SOUTH LAKE ELEMENTARY SCHOOL MAJOR CAPITAL PROJECT COMMUNITY MEETING 01 – 09/21/20

MEETING CHAT RECORD

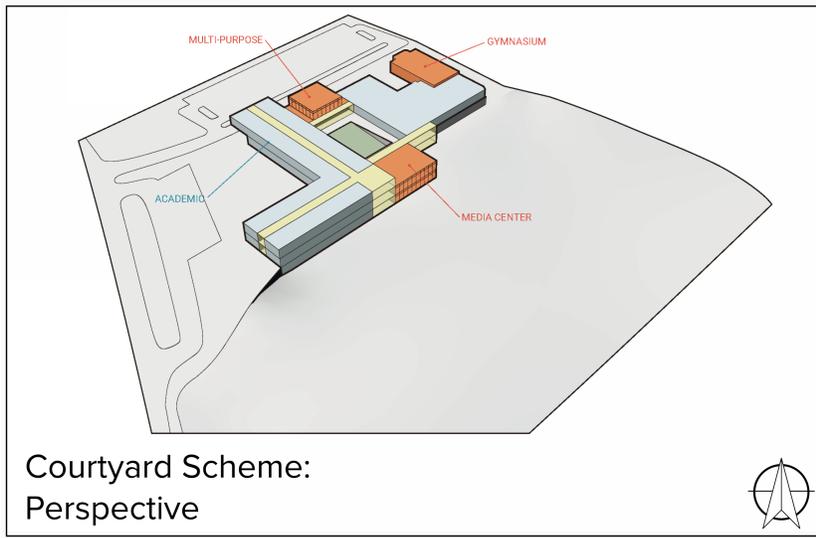
16:56:03 Maria Romero: I'm confused. Media center will be in the lower level?

RESPONSE: This Scheme proposes the Media Center and Multipurpose Room at the lower level where these spaces would be adjacent to outdoor space and provide opportunities for community access.

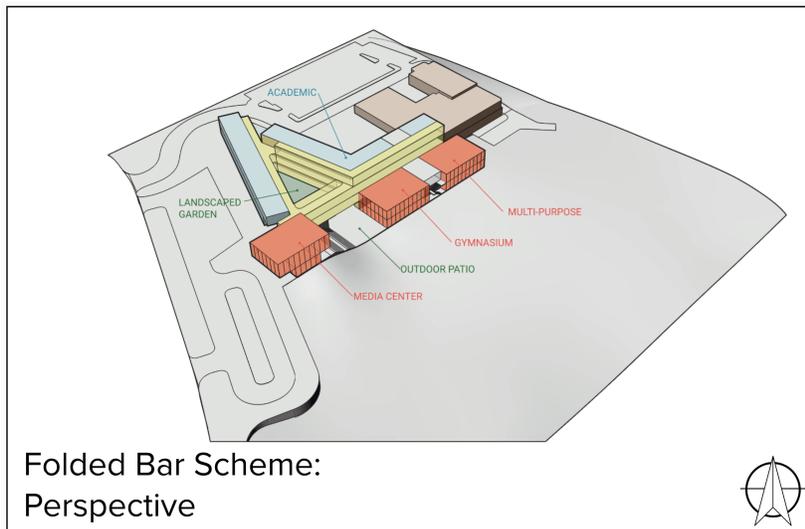
17:16:21 Judy Barth: could the patio be created as an amphitheater?

RESPONSE: Functions within the courtyard can be further explored for future development.
